#### Airworthiness Directives; Airbus Airplanes

**ACTION:** Notice of proposed rulemaking (NPRM).

**SUMMARY:** We propose to adopt a new airworthiness directive (AD) for all Airbus Model A318; A319; A320; and A321 series airplanes. This proposed AD was prompted by reports of premature aging of certain passenger chemical oxygen generators that resulted in the generators failing to activate. This proposed AD would require an inspection to determine if certain passenger chemical oxygen generators are installed and replacement of affected passenger chemical oxygen generators. We are proposing this AD to prevent failure of the passenger chemical oxygen generator to activate and consequently not deliver oxygen during an emergency, possibly resulting in injury to the airplane occupants.

**Airbus:** Docket No. FAA-2015-3989; Directorate Identifier 2014-NM-250-AD.

Figure 1 to paragraph (g) of this AD - location of date (MM-YY)

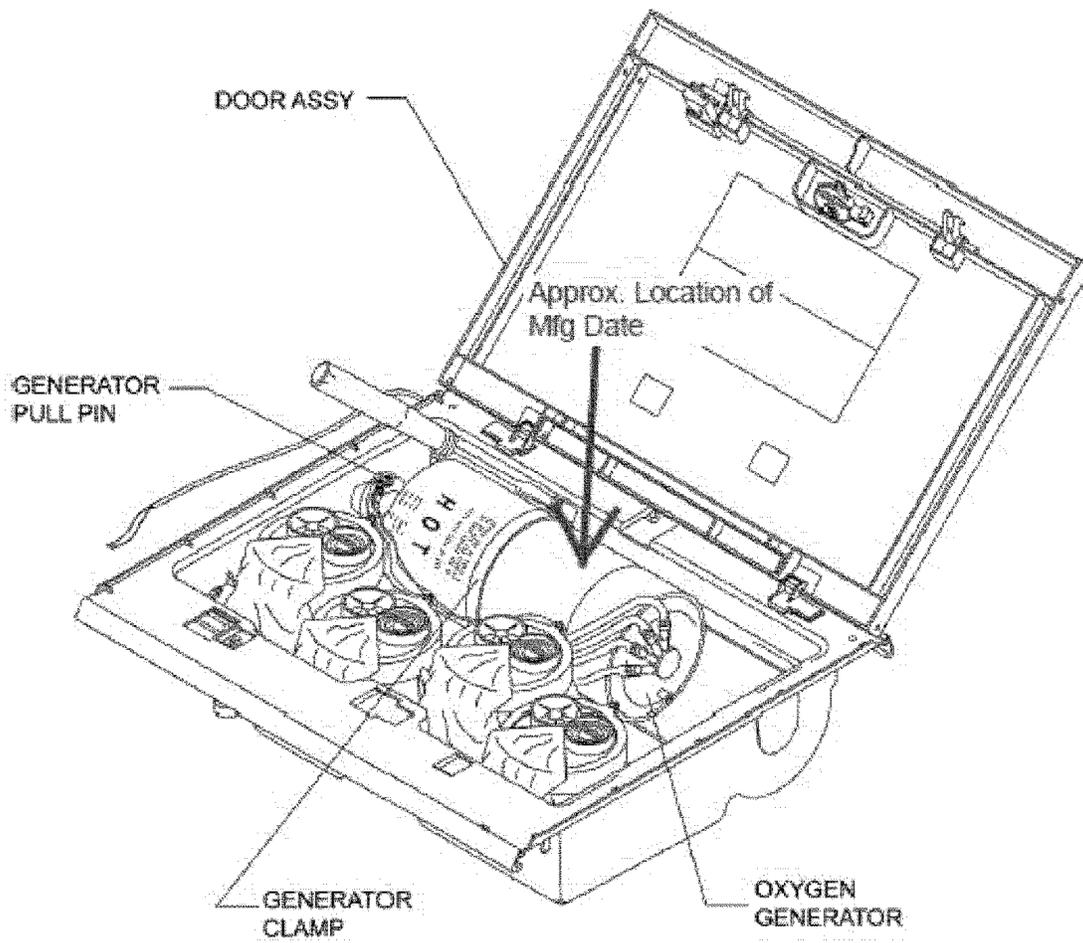
Within 30 days after the effective date of this AD, do a one-time inspection of passenger chemical oxygen generators, part numbers (P/N) 117042-02 (15 minutes (min)-2 masks), 117042-03 (15 min-3 masks), 117042-04 (15 min-4 masks), 117042-22 (22 min-2 masks), 117042-23 (22 min-3 masks), and 117042-24 (22 min-4 masks) to determine the date of manufacture as specified in Airbus Alert Operators Transmission (AOT) A35N006-14, dated December 10, 2014, including Appendix 01. Refer to figure 1 and figure 2 to paragraph (g) of this AD for the location of the date. A review of airplane maintenance records is acceptable for the inspection required by paragraph (g) of this AD, provided the date of manufacture can be conclusively determined by that review.
